SUNDRY NOTICES AND REPORTS ON WELLS

Yates Petroleum Corporation plans to plug and abandon this well as follows:

Yates Petroleum Corporation
NM-92146: Arley Federal Unit #1
API: 30-015-32684
Eddy County, New Mexico

RE: Plugging and Abandonment Requirements, Conditions of Approval

After

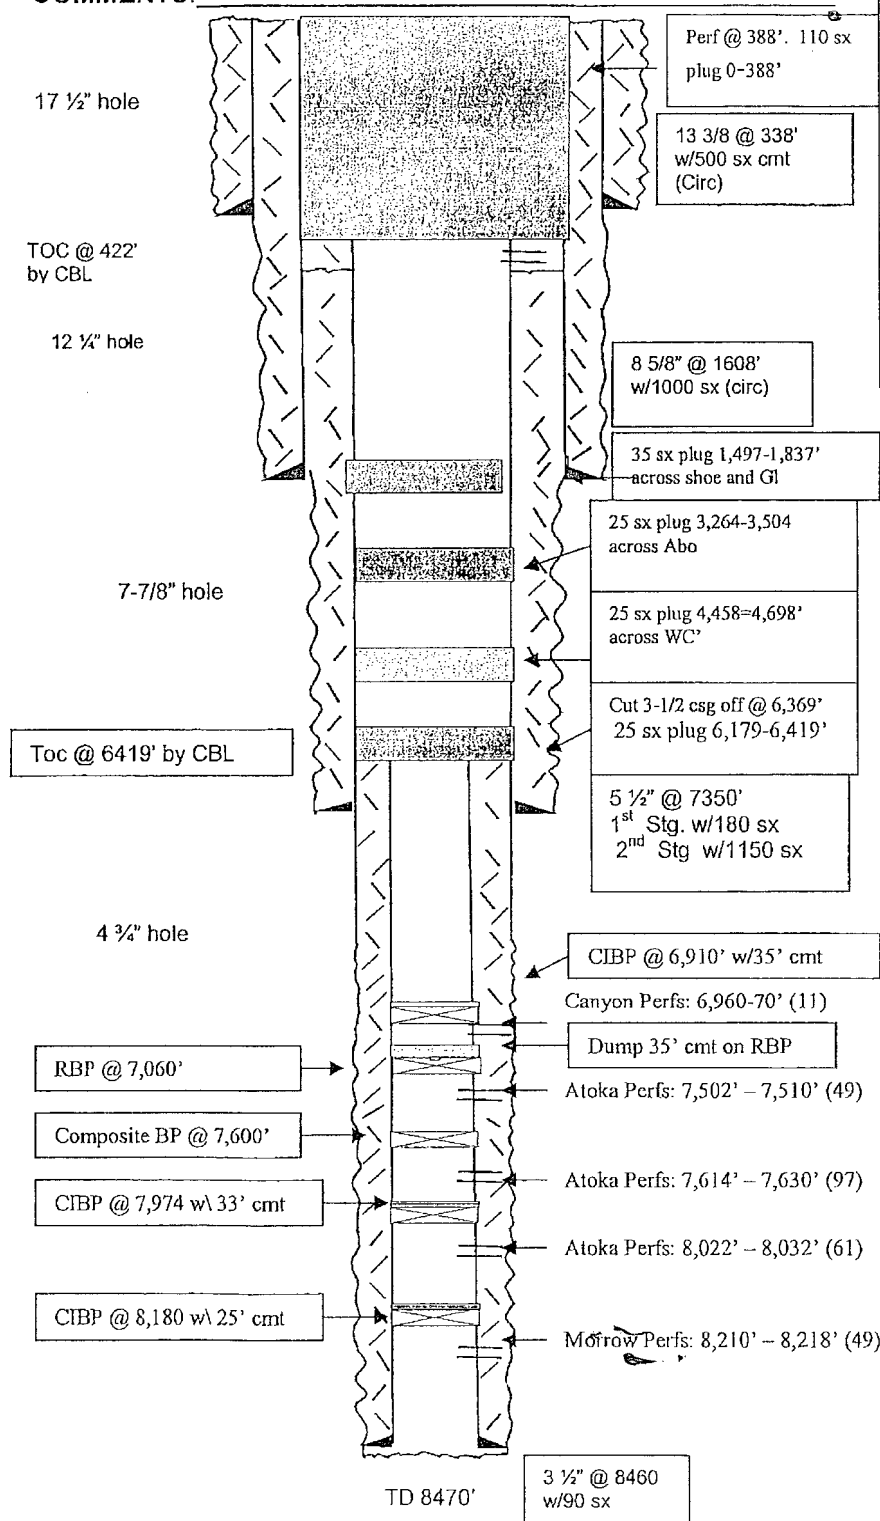
1. MIRU WSU. NU BOP. Rig up all safety equipment as needed. 6369' of casing recovery will be attempted.
2. Dump bail 35' cement on top of the RBP at 7060'. Set a CIBP at 6910' with 35' cement on top. This will place a plug over open Canyon perforations.

3. Cut the 3-1/2" casing at 6369' and pull. Pick up 2-7/8" work string and spot a 25 sx Class "C" cement plug across the top of the 3-1/2" casing stub inside the 5-1/2" intermediate casing from 6179'-6419'.

4. Spot a 25 sx cement plug from 4458'-4698'. This will leave a plug across Wolfcamp top.
5. Spot a 25 sx cement plug from 3264'-3504'. This will leave a plug across Abo top.

6. Spot a 35 sx cement plug from 1497'-1837'. This will leave a plug across Glorieta top and intermediate casing shoe.
7. Perforate the 5-1/2" casing at 388' and establish circulation up the 5-1/2" x 8-5/8" annulus. Pump a 110 sx Class "C" cement and do not displace. This will leave a plug inside and outside casing from the surface down to and across surface casing shoe.

8. Remove all surface equipment and weld dry hole marker per regulations.

1. OK
2. Change: Take out RBP and set CIBP at 7450'. Spot 25sx cement on top of CIBP at 7450. Canyon perf CIBP OK as proposed. If cement from CIBP at 7450' is tagged at 6910' or shallower, Canyon CIBP can be omitted (Perfs – Casing shoe)
3. Spot from 50' inside stub to 120' above the stub. WOC and tag to verify length - Otherwise OK (Stub)
4. OK (Wolfcamp)
5. OK (Abo)
6. Move: Spot cement from 1890'-1550'. 35sx approved. WOC and tag at 1550' or shallower – Otherwise OK (Glorietta – Casing shoe)
7. OK (Surface – Casing shoe)
8. Verify that all annuluses have cement to surface and fill in as required – Otherwise OK
9. Submit a subsequent report to the BLM.
